STATE OF MAINE, ACTING THROUGH THE )	PETITION TO REVOKE,
STATE PLANNING OFFICE )	MODIFY OR SUSPEND
OLD TOWN, PENOBSCOT COUNTY, MAINE )	SOLID WASTE LICENSE
JUNIPER RIDGE LANDFILL )	
CHANGE IN MSW BYPASS LIMIT )	
#S-020700-WD-W-M )	DISMISSAL

Department staff review memorandum

## MEMORANDUM

To: Cynthia W. Darling; Project Manager – Eastern Maine Regional Office  
From: Amanda S. Wade, P.E.; Environmental Engineer – Technical Services  
Date: July 27, 2011  
Subject: Juniper Ridge Landfill  
Affidavit of Denis St. Peter

## PTL Phase VI Leachate Collection Issues

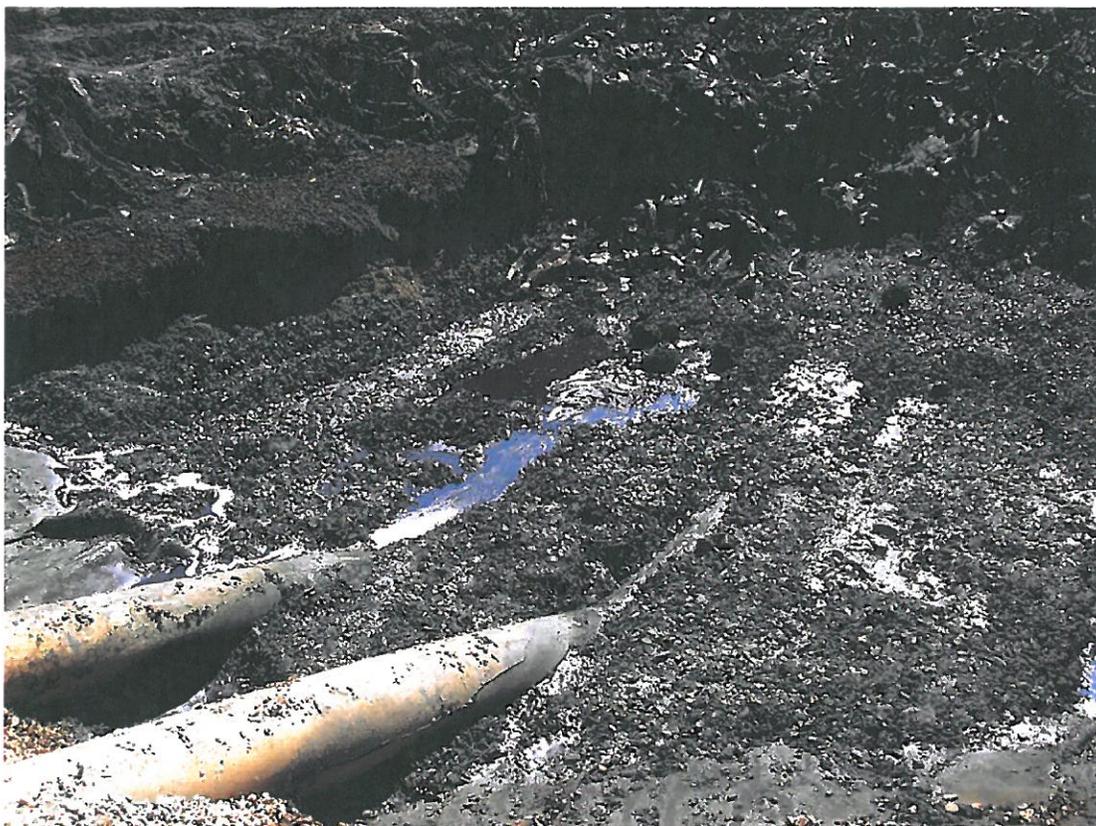
Leachate that backed up along the landfill berm because the leachate collection layer was blinded by the soft layer.  
Note the layer of ash and FEPR seen just above the leachate.

Phase VI sump excavation. Note the deposits on the leachate collection stone that led to the back up of leachate.

Phase VI sump. Note the layers of clean sand and stone around the perimeter of the sump indicating that leachate was not able to penetrate through the soft layer in these areas to get to the leachate collection system.

Picture of Phase VI sump from afar to show location of waste in relation to the sump. The dark layer of material just above the leachate collection sand is the soft layer placed in the cell and consisted of FEPR and ash.
